TECHNICAL BULLETIN

JTB00522NAS1

Luggage Compartment Lid-To-Rear Bumper Foul When Closing

XE (X760)

E197069

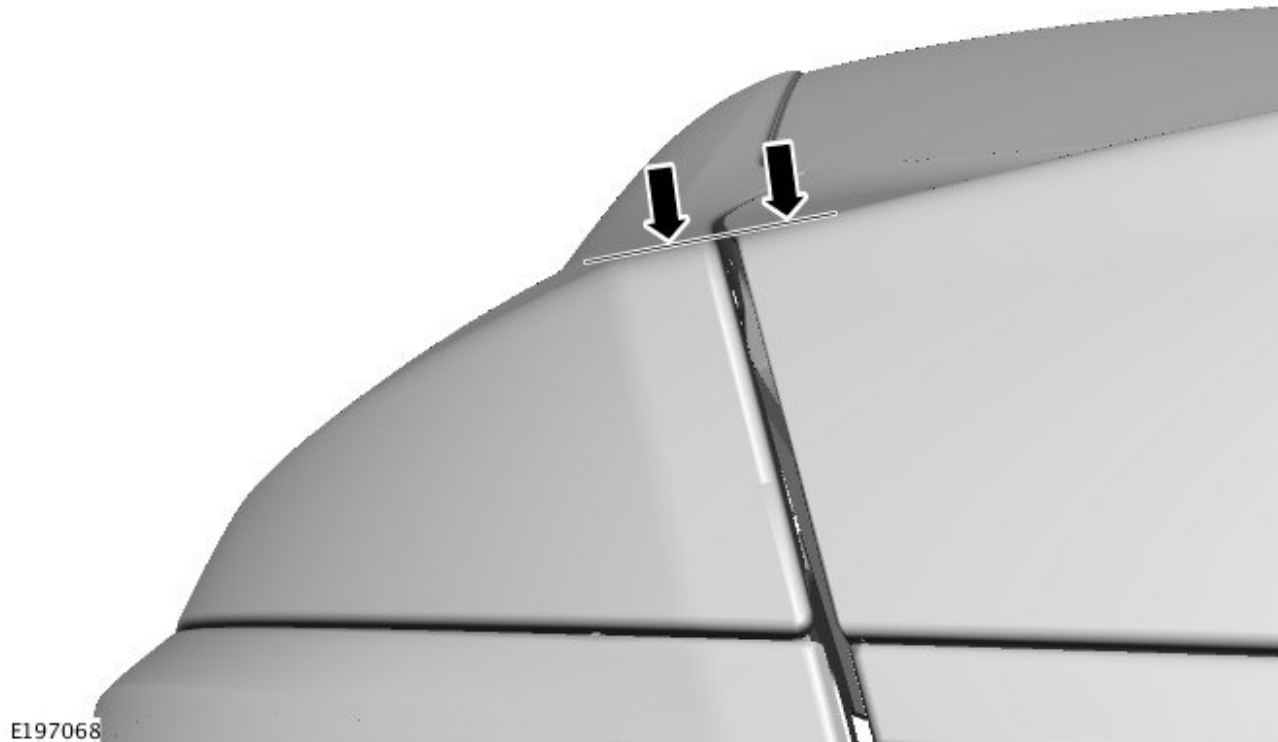
3. With the luggage compartment lid closed, measure the vertical gap between the bumper and the luggage compartment lid at points A, B and C.

- If all three dimensions are 5.50 mm or more, do not continue with this Service Instruction.
- If any of the three dimensions is less than 5.50 mm, go to Step 4.

E197067

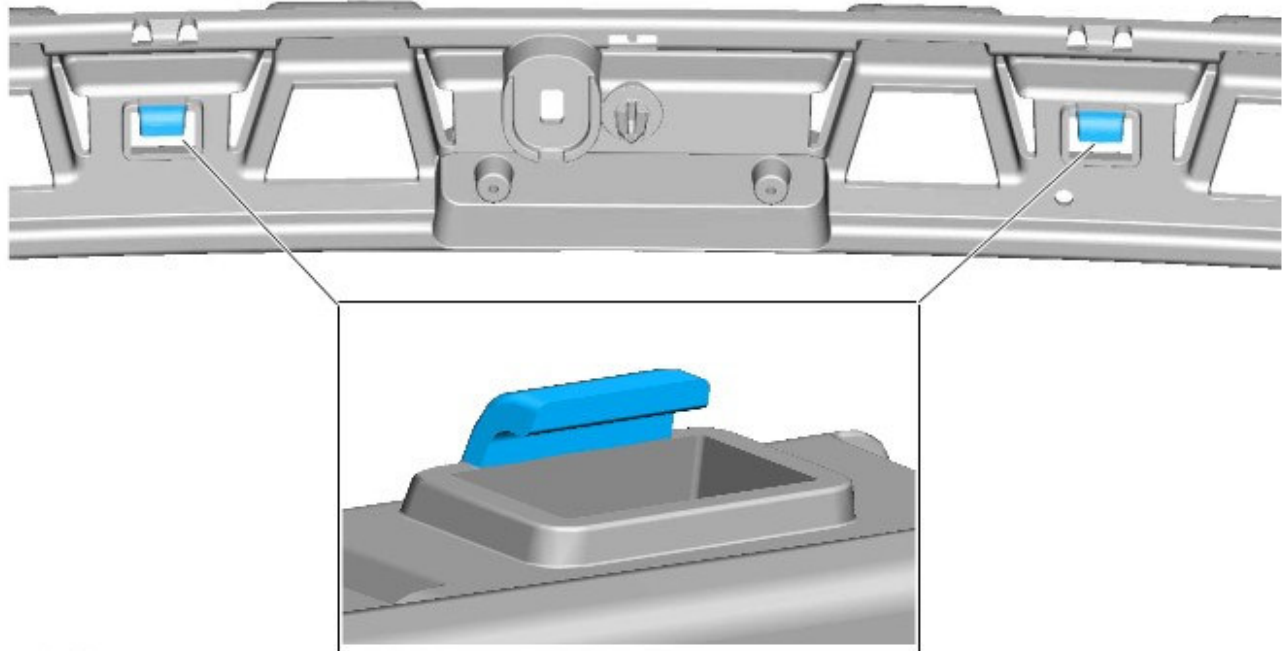
10. Using a suitable tool, remove and discard the two hooks from the rear bumper support bracket.

E197401

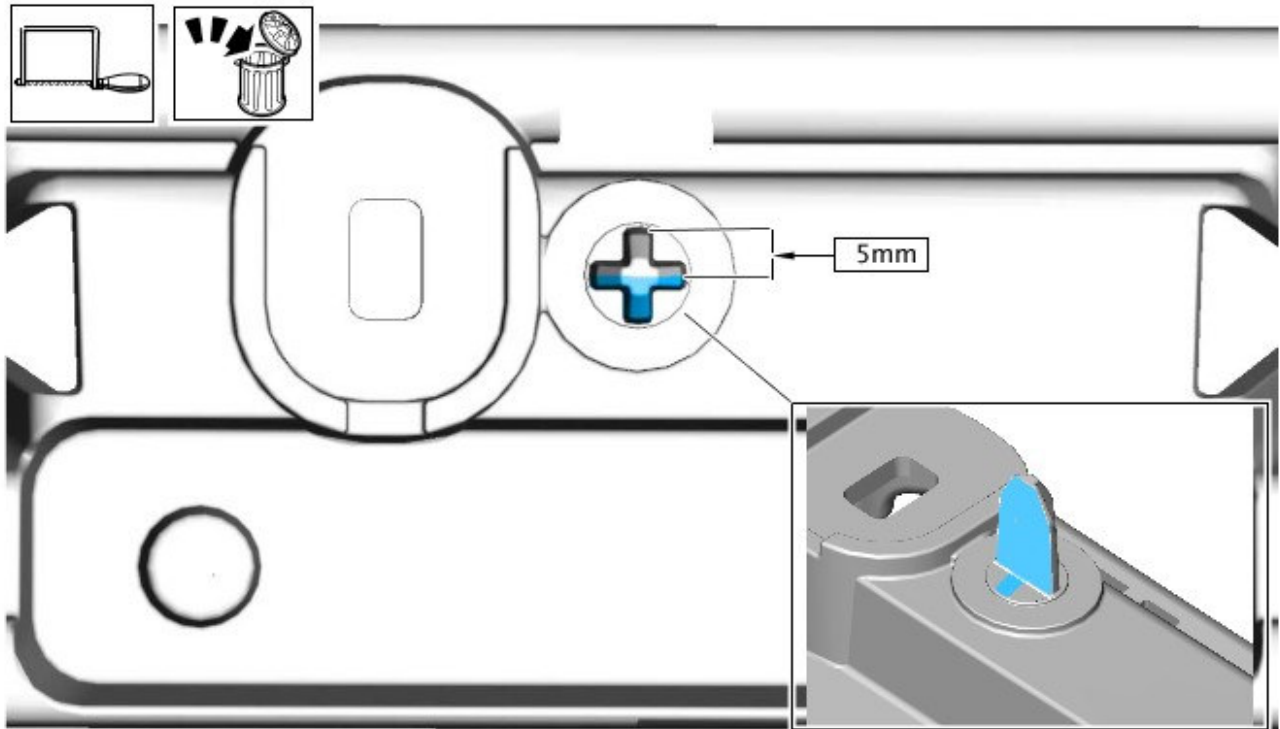
- 12.** Using a suitable tool, remove the section of the Y center locator flush with the base as shown in blue. The remaining piece of the Y center locator should be 5mm as shown.

E197355

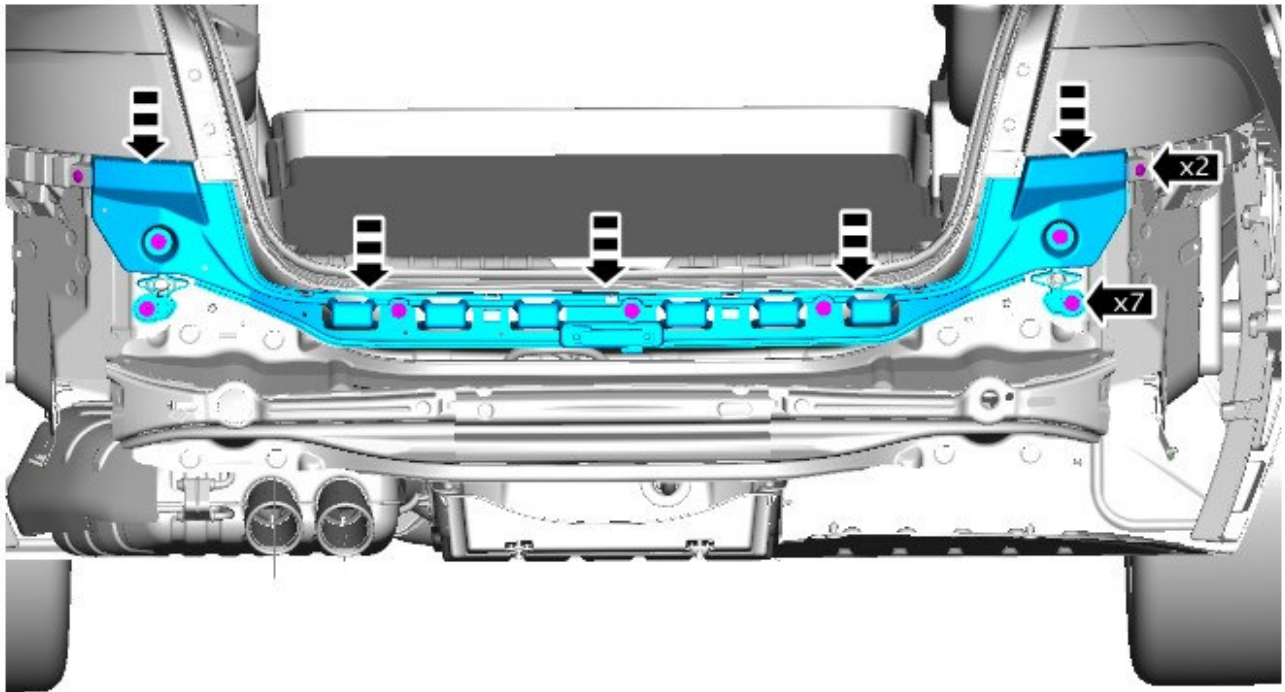
13. Install the rear bumper support bracket.

- Starting from the center fixing, working outwards while pushing down on the bracket, tighten the fixings to lower the installed position of the bracket.
 - Torque: **1.7Nm**

E197209

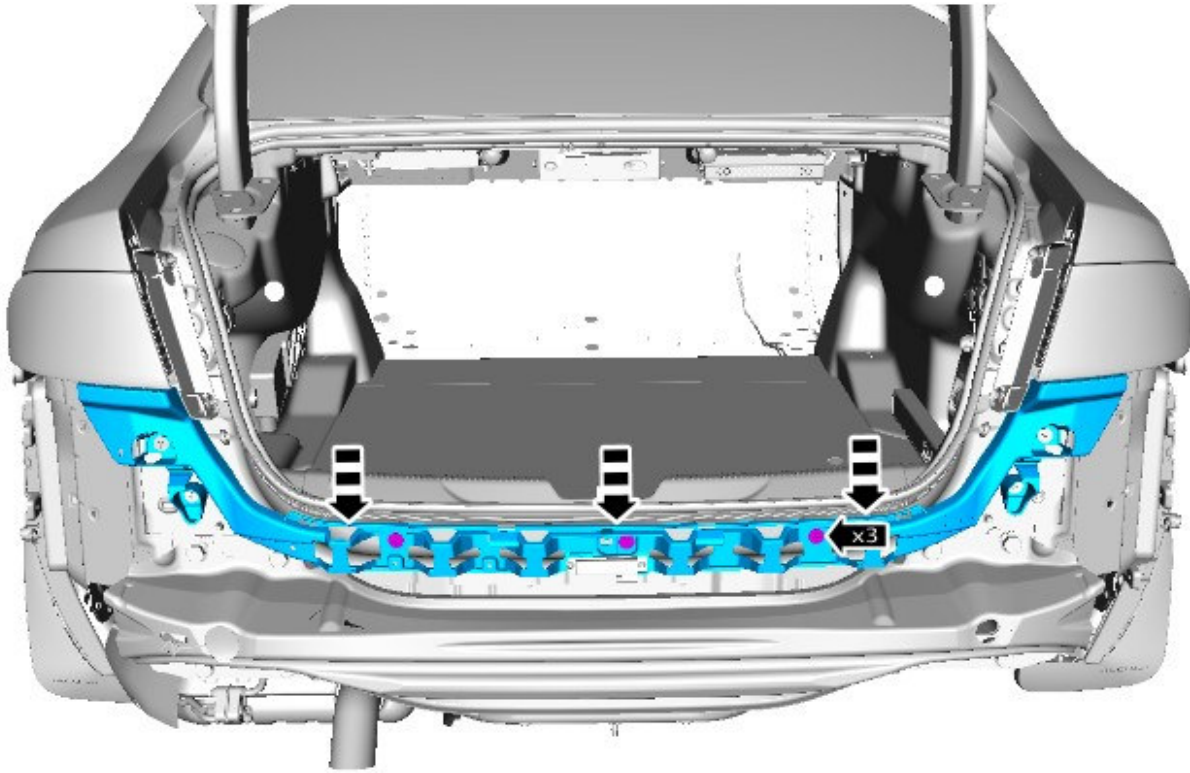
18. Starting from the center fixing, working outwards while pushing down on the bracket, tighten the fixings to lower the installed position of the bumper support bracket.

- Torque: **1.7Nm**

E197071

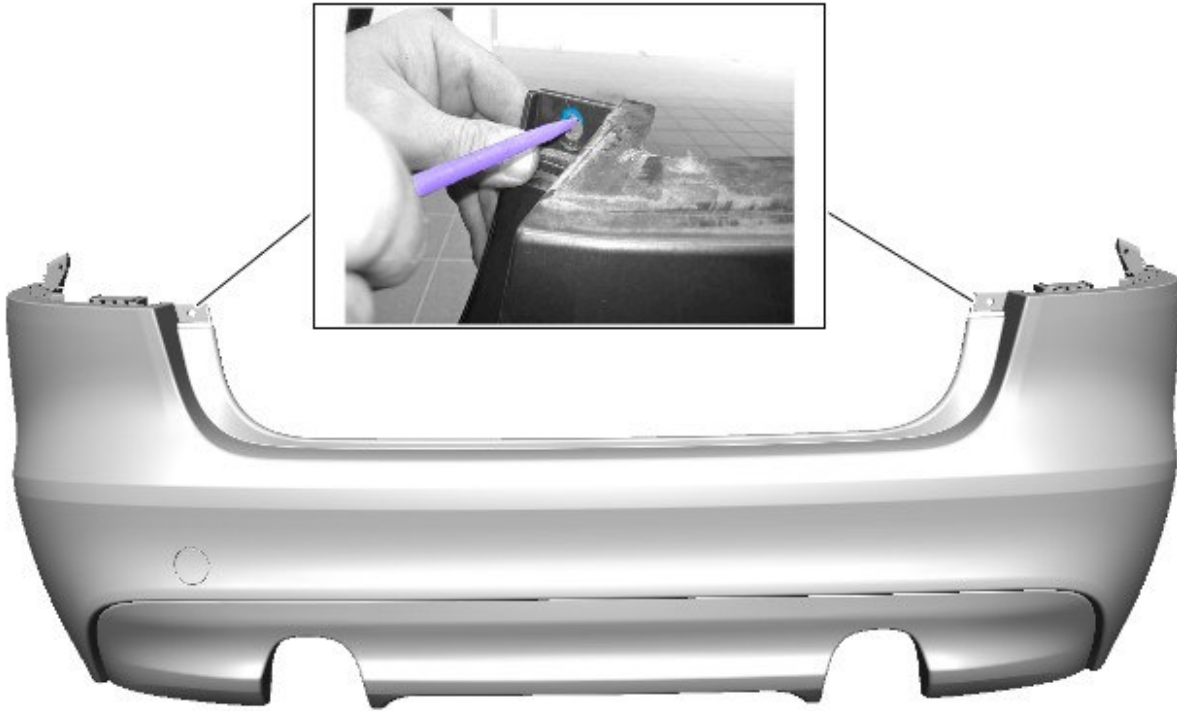
- 19.** Using a suitable tool, enlarge the two bumper holes as shown to increase the vertical height of the hole at the top by 1-1.5mm.
